No. 2360
ATA Code 53-10
Recurring Inspection

SUBJECT: FUSELAGE - WING FORWARD SPAR CARRY-THRU STRUCTURE INSPECTION AND/OR REINFORCEMENT

BD-764 M

Inspection for Cracks in the Wing Forward Spar Carry-Thru
Figure 1

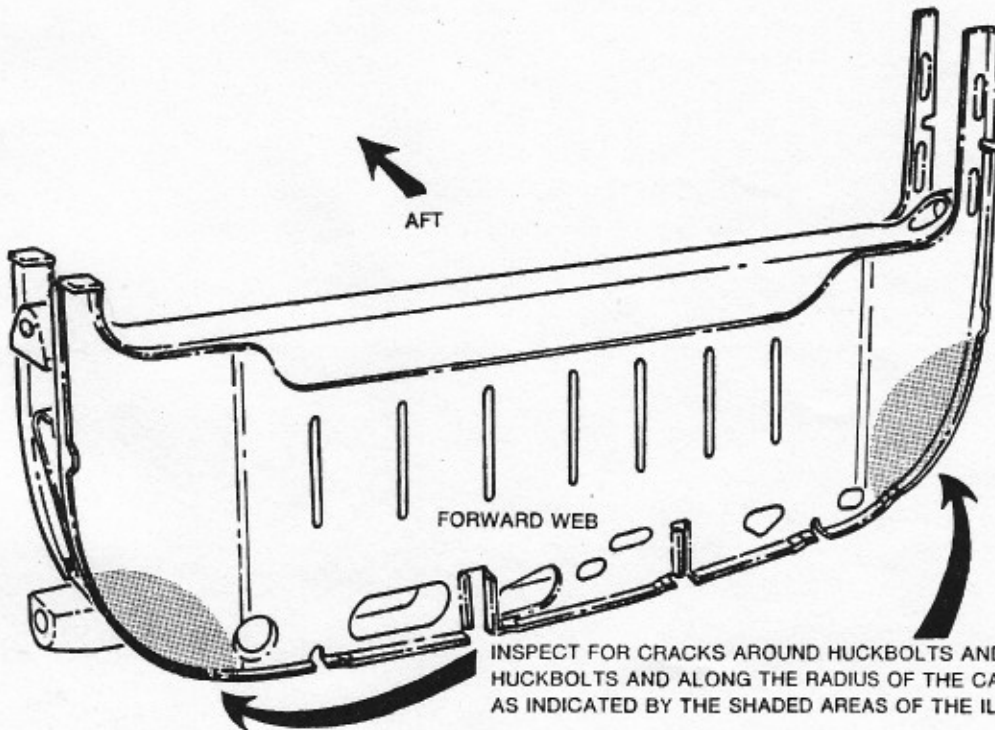
INSPECT FOR CRACKS AROUND HUCKBOLTS AND BETWEEN HUCKBOLTS AND ALONG THE RADIUS OF THE CARRY-THRU WEB AS INDICATED BY THE SHADED AREAS OF THE ILLUSTRATION

INSPECT FOR CRACKS AROUND HUCKBOLTS AND BETWEEN HUCKBOLTS AND ALONG THE RADIUS OF THE CARRY-THRU WEB AS INDICATED BY THE SHADED AREAS OF THE ILLUSTRATION

The first inspection must be performed no later than the first 1500 flight hours. If an airplane has over 1500 flight hours, the inspection is to be accomplished at the next scheduled inspection. If no cracks are found repeat the inspection every 500 hours.

Any of the areas shown in Figure 1 that are modified by the installation of a doubler need not be dye-penetrant inspected until 1500 flight hours after the installation of that particular doubler. If no cracks are found, repeat the inspection every 500 flight hours.

Areas shown in Figure 1 that have cracks that fall within allowable limits and that have not been modified by a doubler must be inspected or repaired as indicated in this Service Bulletin on an individual basis.

1) A crack up to 2.25 inches in length must be stop drilled #30 at crack ends and inspected for progression at each annual inspection or every 200 hours, whichever occurs first. One stop drilled crack per left side and one stop drilled crack per right side of the wing forward spar carry-thru structure bend radius are permissible, if neither one exceeds 2.25 inches.

2) A crack between 2.25 inches and 4.0 inches in length shall be stop drilled #30 at crack ends. The area is to be repaired per the applicable P/N 36-4004 Kit within the next 100 flight hours.

3) A crack exceeding 4.0 inches in length shall be repaired prior to further flight per the applicable P/N 36-4004 Kit.

1) A crack less than 1.0 inch in length or one crack between two fasteners does not require immediate repair, but shall be inspected for progression at each annual inspection or every 200 hours, whichever occurs first. A crack emanating from one fastener in two directions is considered to be one crack. **Do not stop drill, due to the possibility of damaging structure behind web face.** One crack per left side and one crack per right side of the wing forward spar carry-thru structure web face are allowed, if neither one exceeds 1.0 inch.

2) A crack more than 1.0 inch in length shall be repaired per the applicable P/N 36-4004 kit, within the next 25 flight hours.

A crack which passes through two fasteners but is less than 0.5 inch beyond either fastener shall be repaired per the applicable P/N 36-4004 kit within the next 25 flight hours.

3) A crack passing through two fasteners and extending beyond for more than 0.5 inch on either end shall be repaired prior to further flight, per the applicable P/N 36-4004 kit.

c. A combination of the cracks described in Steps "a" and "b" is acceptable. If cracks are found in both the forward and aft web face and/or the bend radius on the same side of the airplane, and any of the cracks are more than 1.0 inch long, a repair shall be made prior to further flight.
